# LHC Collimation Review 2013

## **Charge of the review panel:**

# Assessment of performance reach

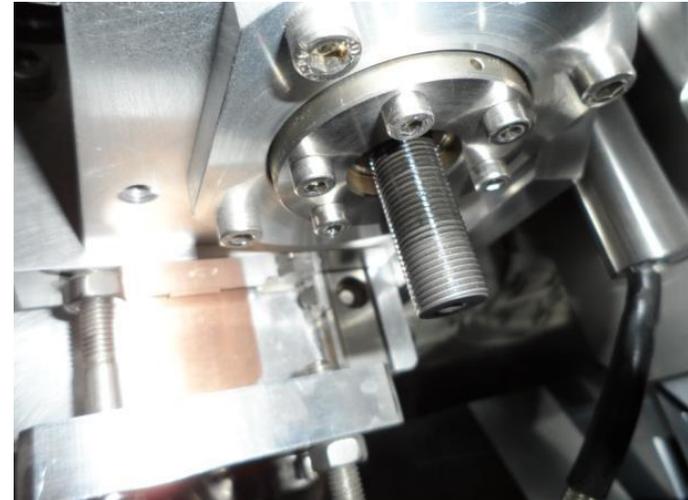
- The quench test at 4 TeV provides a foundation for estimating the performance reach at 7 TeV and suggests sufficient margin. However, extrapolation to 7 TeV is difficult, e.g.:
  - 25 ns bunch spacing
  - Increased impedance may require relaxed collimator settings
  - Reduced beam lifetime due to other reasons
- Without DS collimation in the experimental IRs the heavy ion peak luminosity is expected to be limited to  $3 \times 10^{27} \text{ cm}^{-2} \text{ s}^{-1}$  while the peak luminosity goal after LS2 is  $6 \times 10^{27} \text{ cm}^{-2} \text{ s}^{-1}$  (for ALICE only?)
